2020-04-09

### Request for Tenders for AFRICA PAVILION – WASHROOM UPGRADES RFT No.: TZC T 26-2020-03

### **ADDENDUM 3**

M202

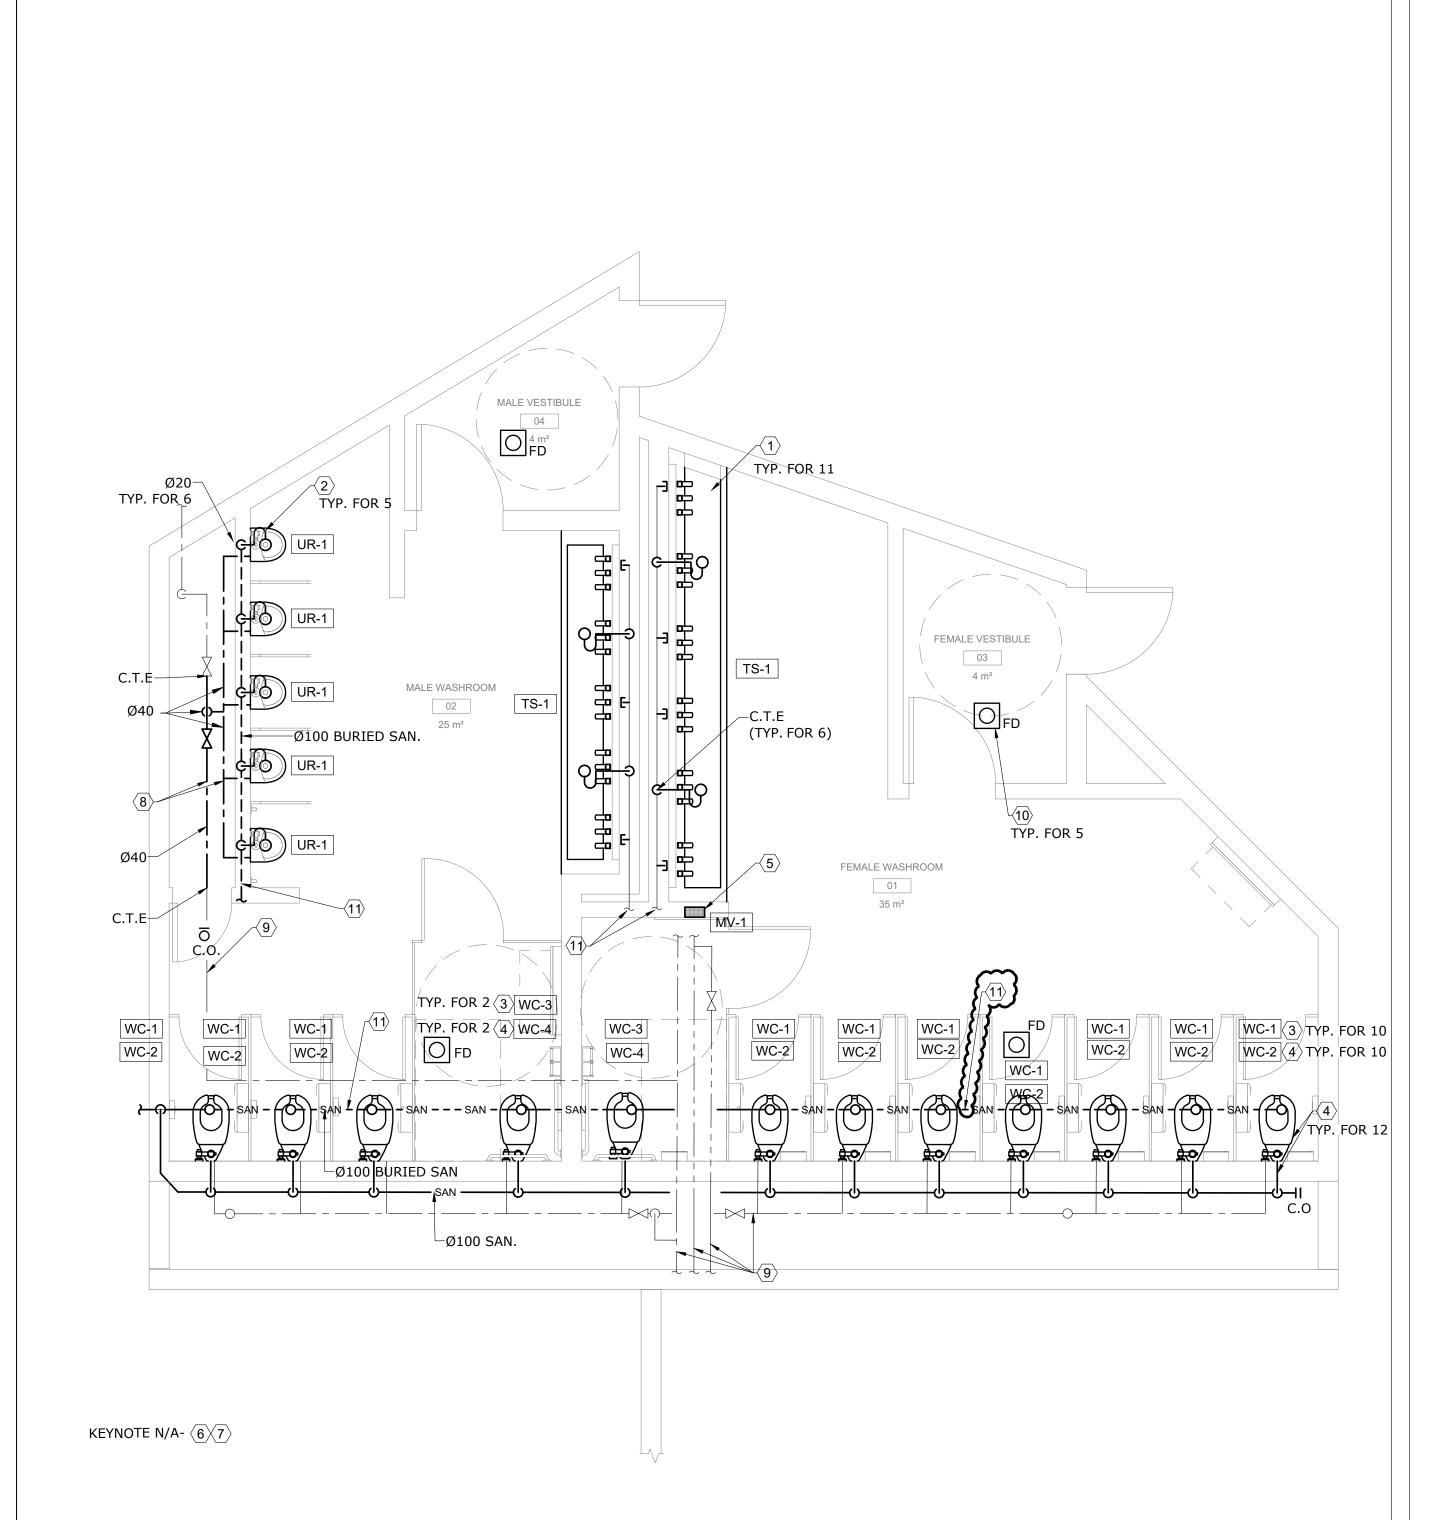
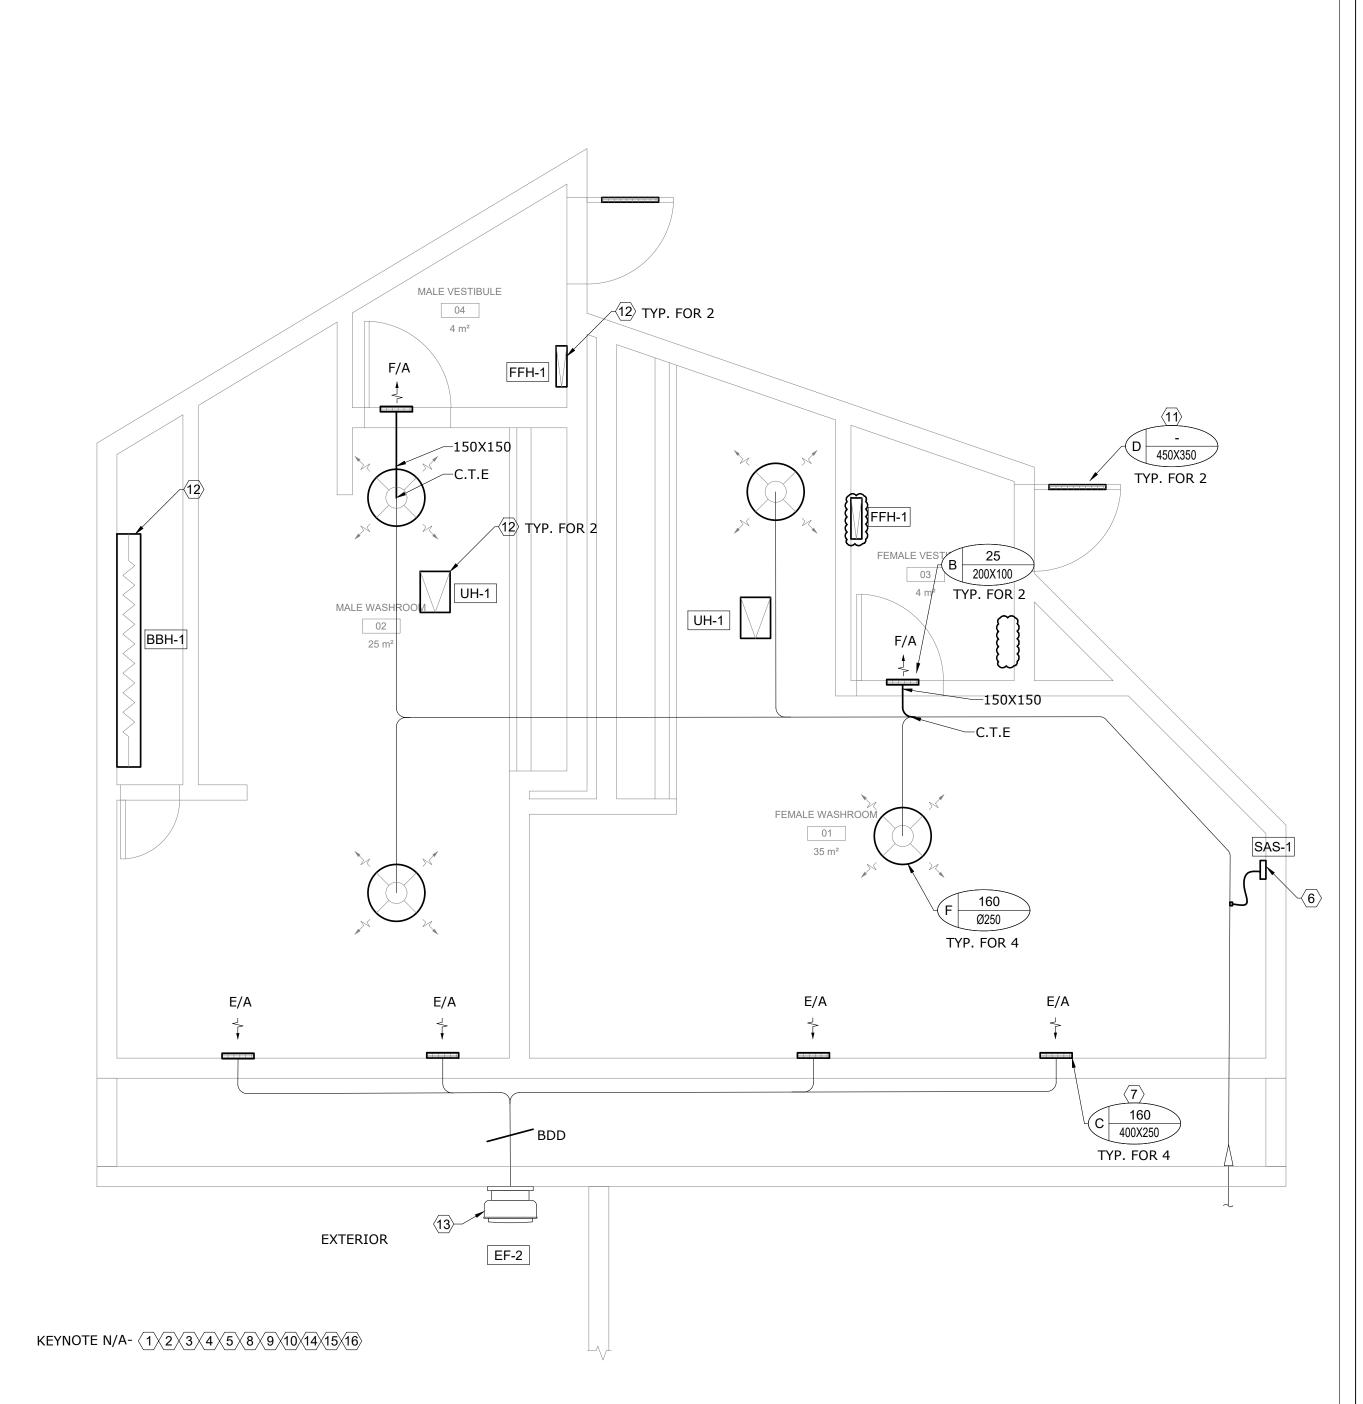
On drawing M202 (plumbing demo) it states notes 5,7,11 are N/A as well as drawing M203 (plumbing modification) states notes 6,7 are N/A, but on the notes these numbers are used. Do we ignore all notes pertaining to these note numbers or do we take them into account?

E-3.1

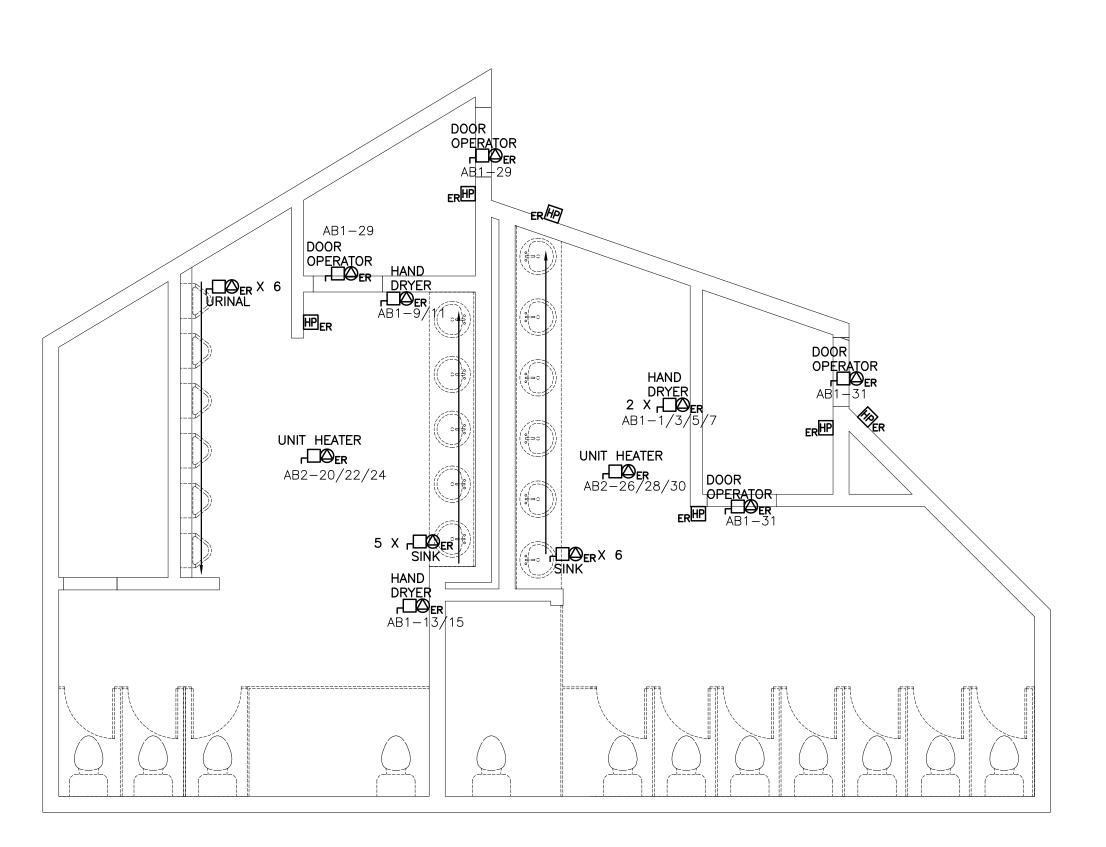
Provide Part # for M1 Fixtures. Panel Schedule for new 84-cct Panel Outside Men's Washroom on drawing E-3.1, shows light fixture LE1A, is this new or existing? Fixture legend does not identify the fixture. If new, please provide part number.
